Summary and recommendations

Pilbara Energy Limited (the proponent) proposes to establish an energy infrastructure in the Pilbara region of Western Australia (Figure 1). This proposal will provide natural gas and electric power for future industrial developments and includes:

**Questions and issues raised in submissions
and the proponent's response**

Figure A.1.6.2 Quarry Road site, Autumn conditions, eight Turbine operating with large enclosure

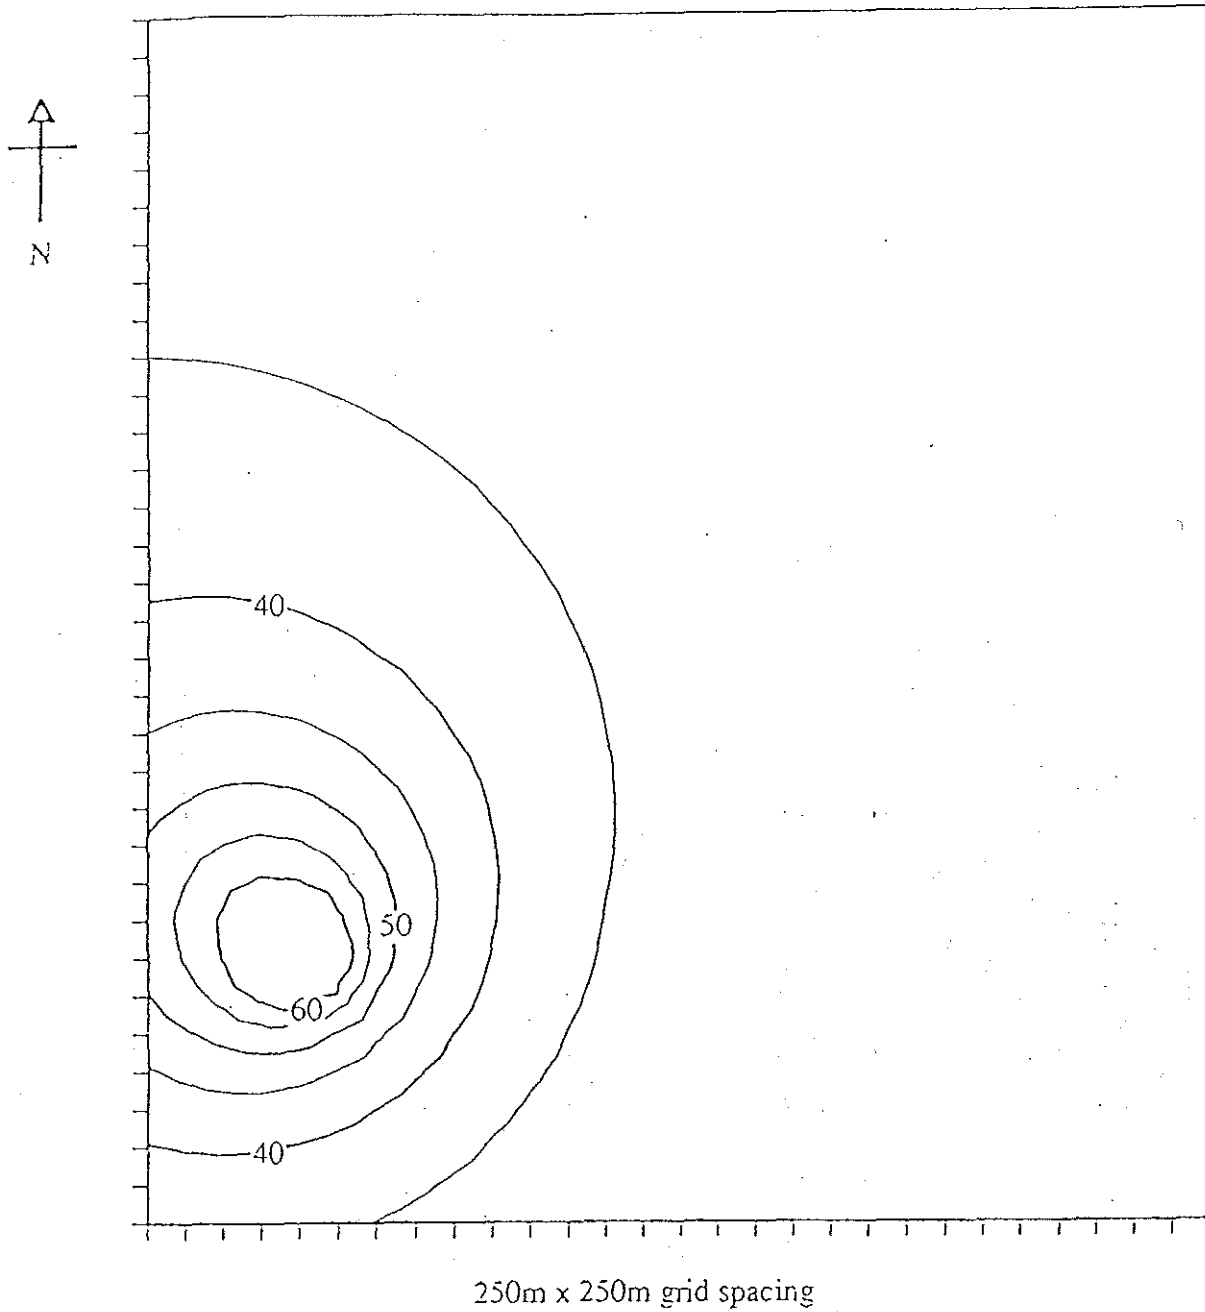
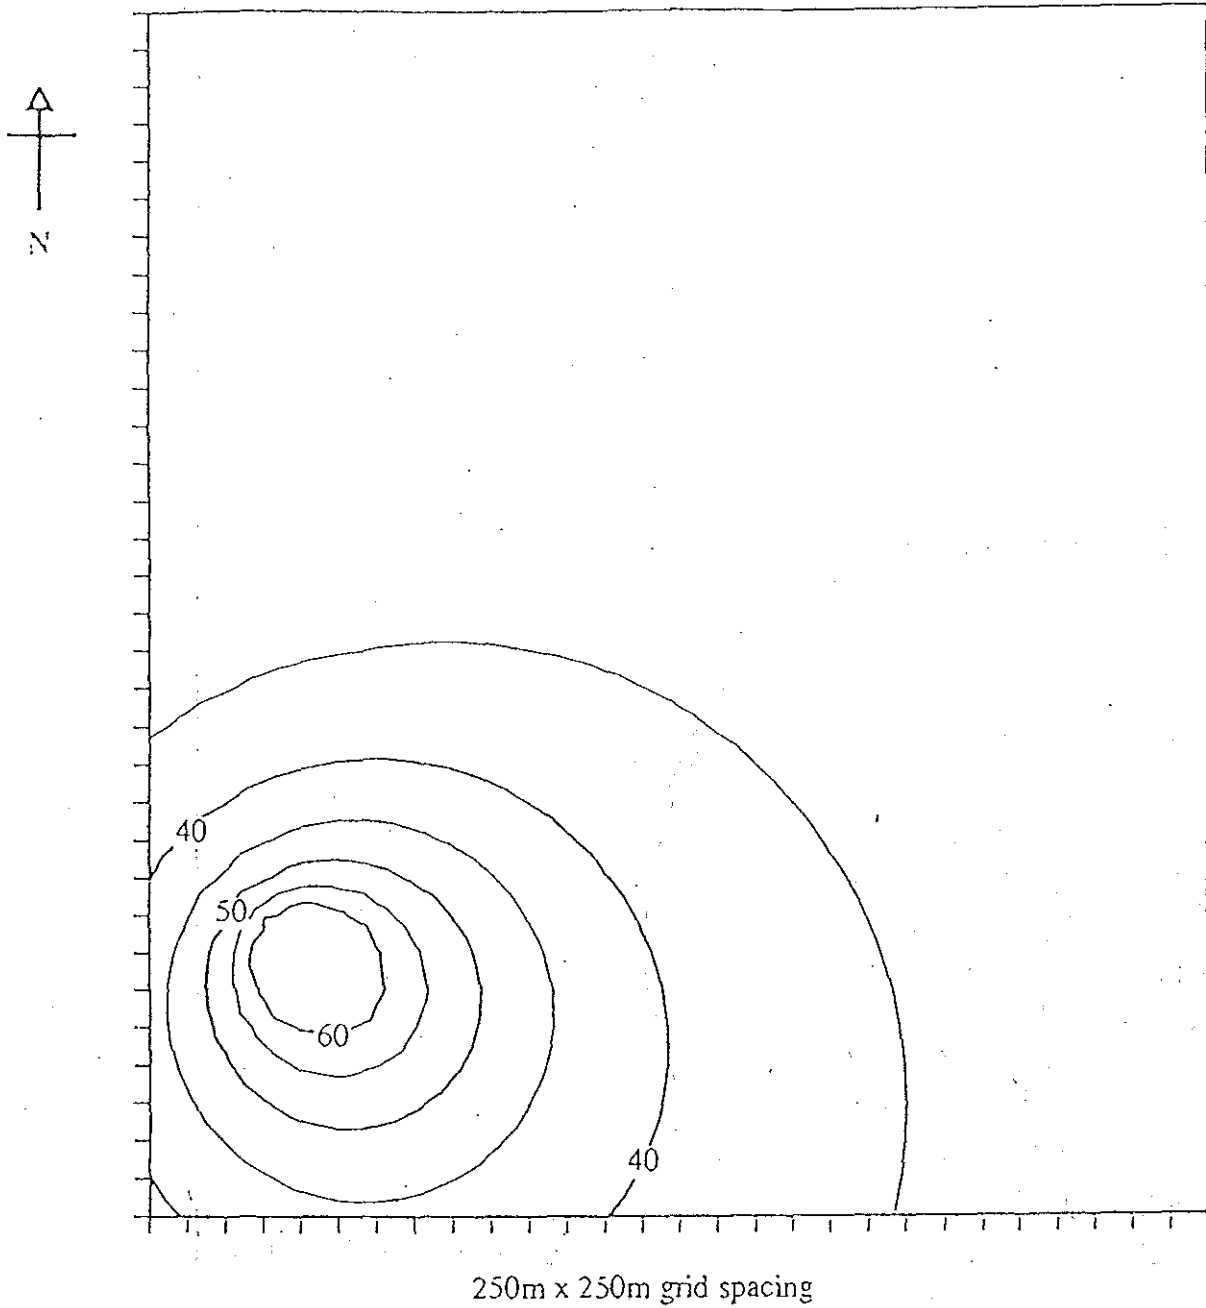
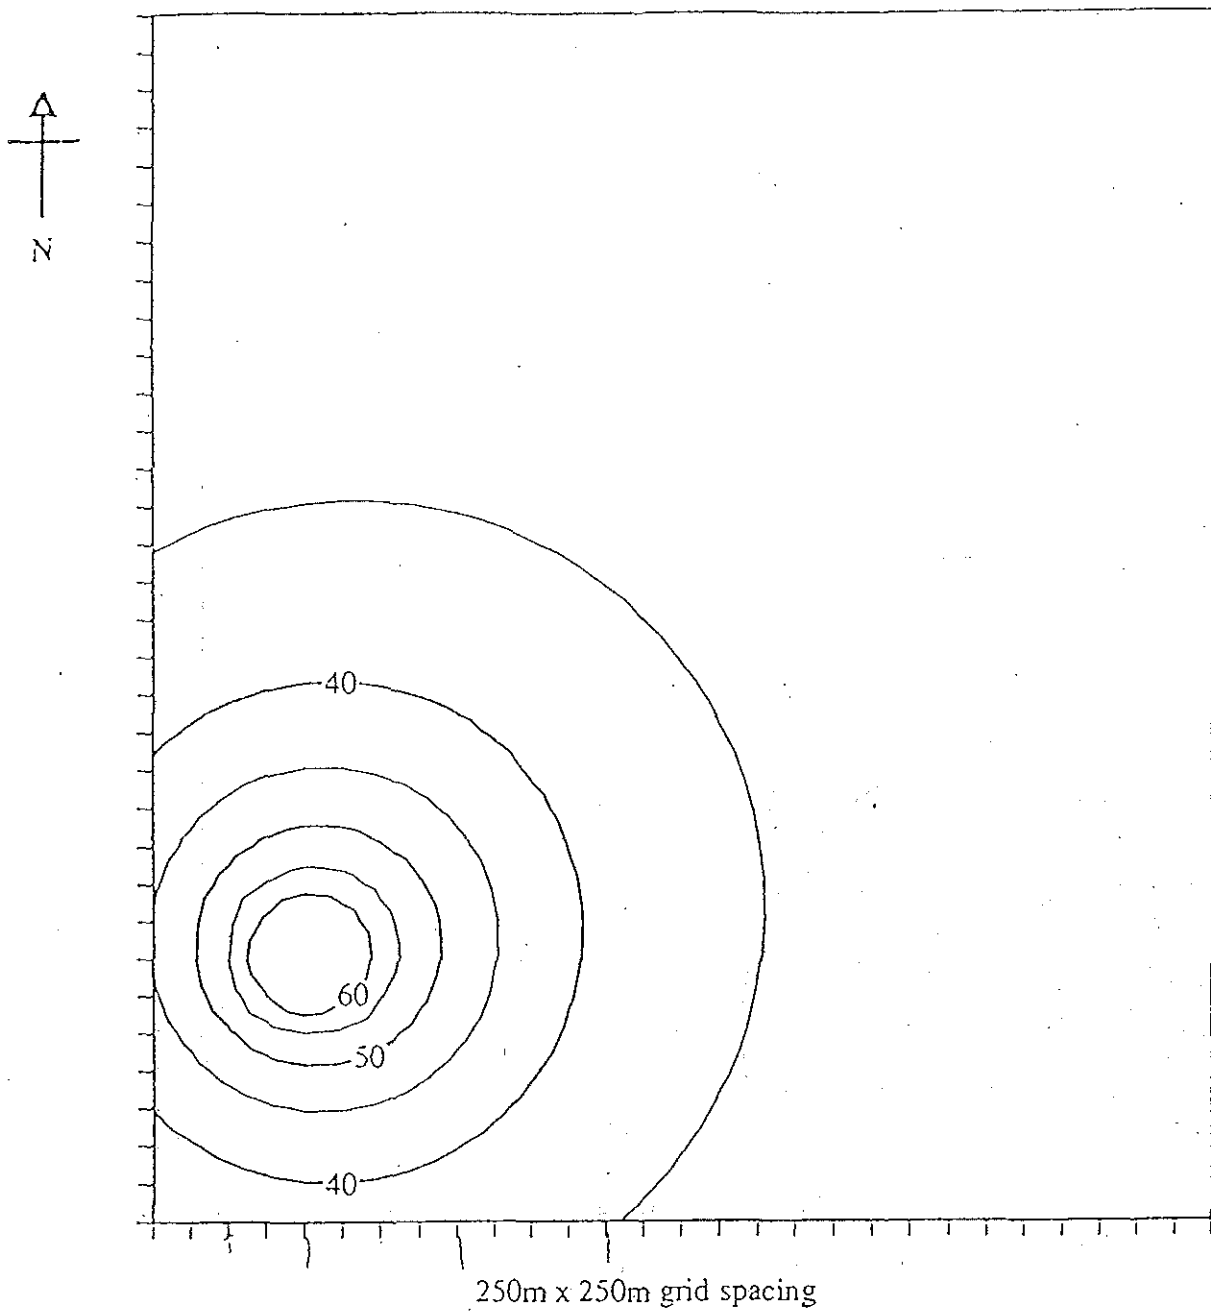
7.1 Q *Elaborate on the 35 dB (A) noise contour in figure 2.1 i.e. what wind conditions (times, seasons etc) does this relate to?*

7.2 Q *Are there any climatic conditions during which noise and gaseous emissions are predicted to impact on residential areas? Provide modelling contours of the worst case noise scenario.*

Figures A1.4.1 to A4.4 show the noise contour with four GT's operating and Figures A1.6.1 to A6.4 show the contours with 8 GT's operating during summer, autumn, winter and spring. These contours are for a site on Quartz Quarry Road, which is no longer viable, but the figures are applicable to the selected power station site.
